By letter dated July 14, 1983 (Serial No. 972), Toledo Edison submitted to the NRC a request for approval for the alternative on-site disposal of very-low-level radioactively contaminated secondary-side clean up resins for the Davis-Besse Nuclear Power Station Unit No. 1. This request was made pursuant to the regulation of 10 CFR 20.302.

RESPONSES TO NRC QUESTIONS DURING TELEPHONE CONVERSATION  
IN NOVEMBER 1984

GROUNDWATER MIGRATION ANALYSIS FOR THE ON-SITE DISPOSAL  
OF LOW-LEVEL RADIOACTIVELY CONTAMINATED RESIN AT  
THE DAVIS-BESSE NUCLEAR POWER STATION

Attachment No. 3  
**8502060150-01**

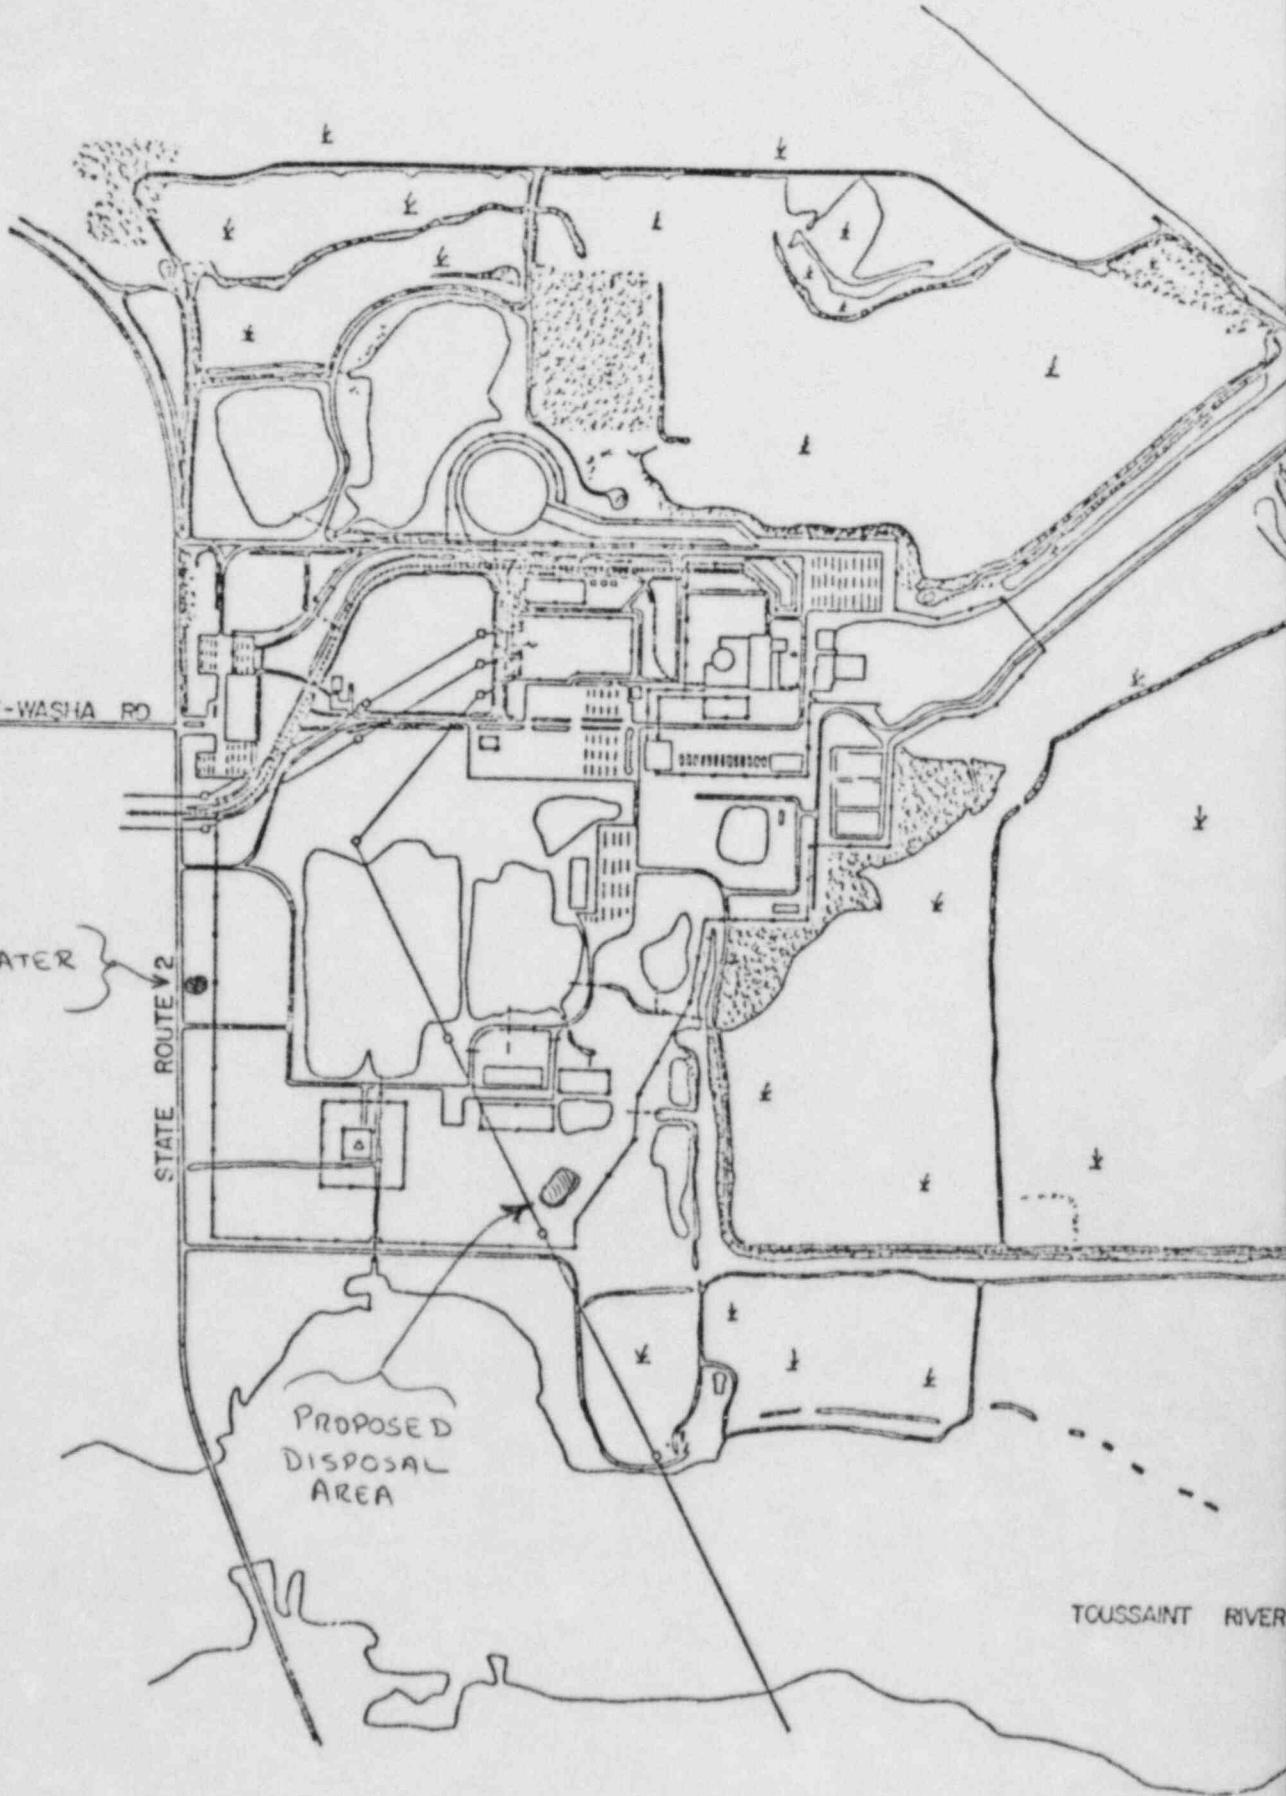
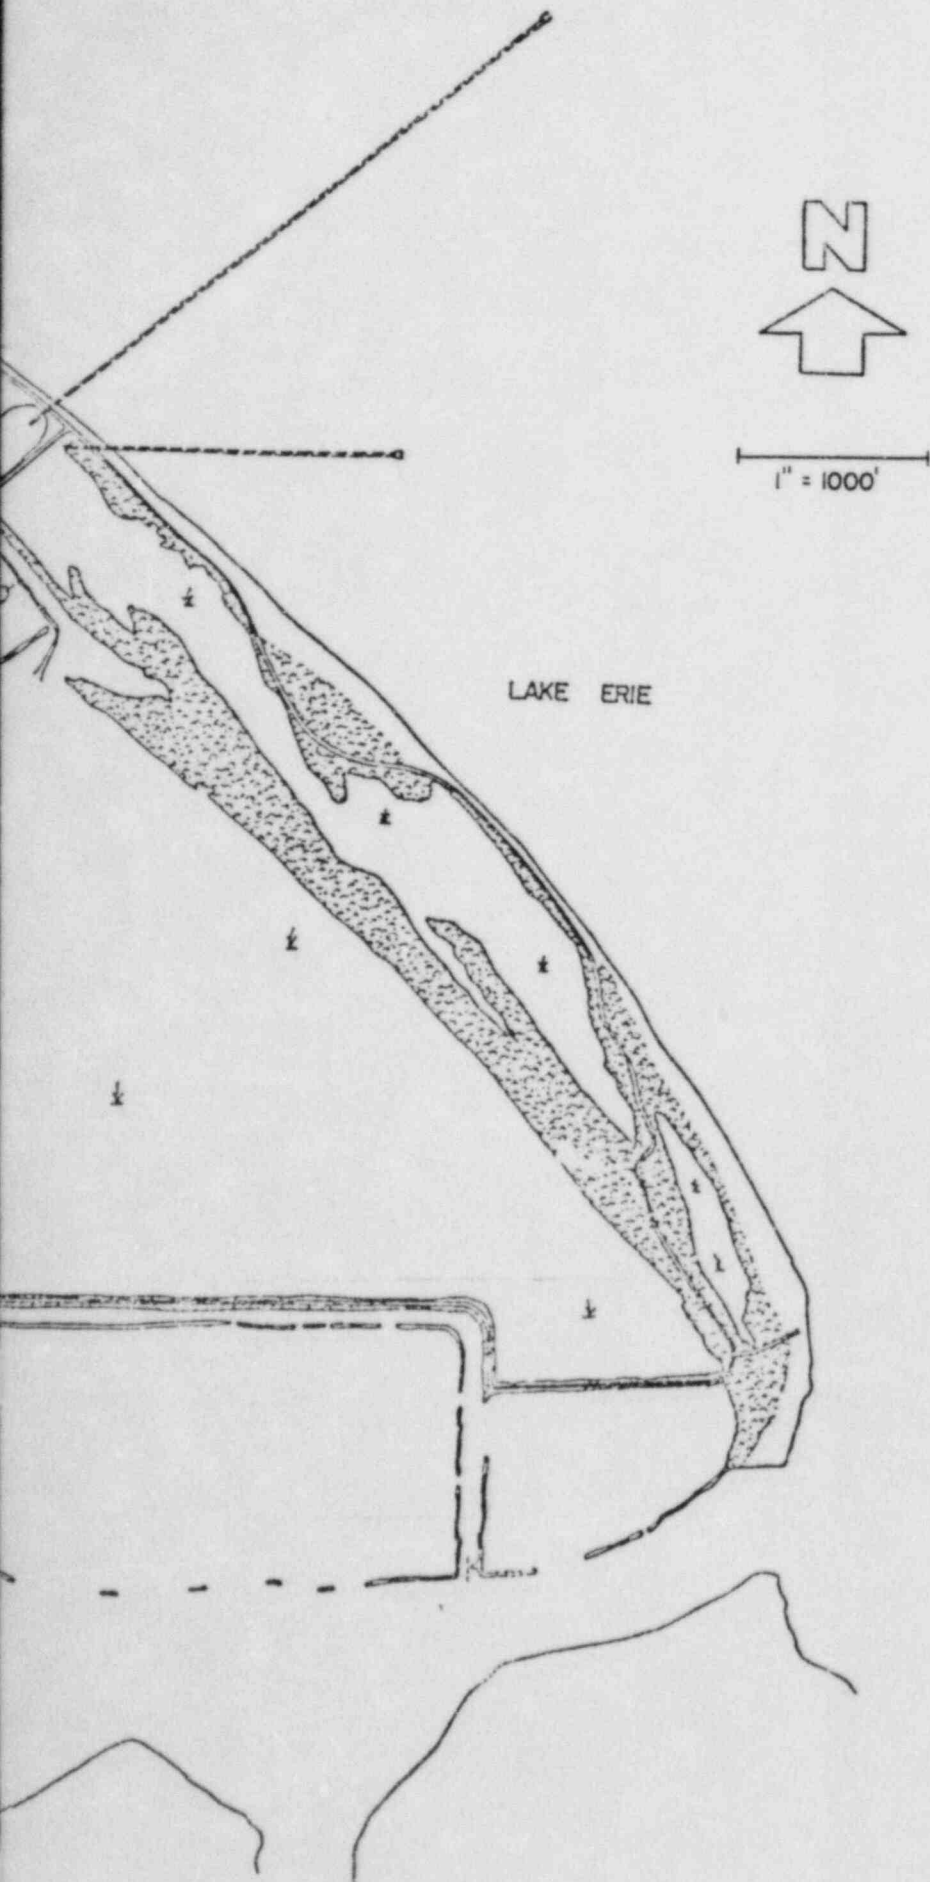
- Question 3: Provide a map indicating the location of the burial site and the worst location for the nearest well.
- Response: Attachment No. 3 indicates the proposed disposal area and the nearest groundwater well to the disposal area. The water from the well is not used for drinking water. Samples are collected quarterly and analyzed for radioactivity as part of the environmental radiological monitoring program.
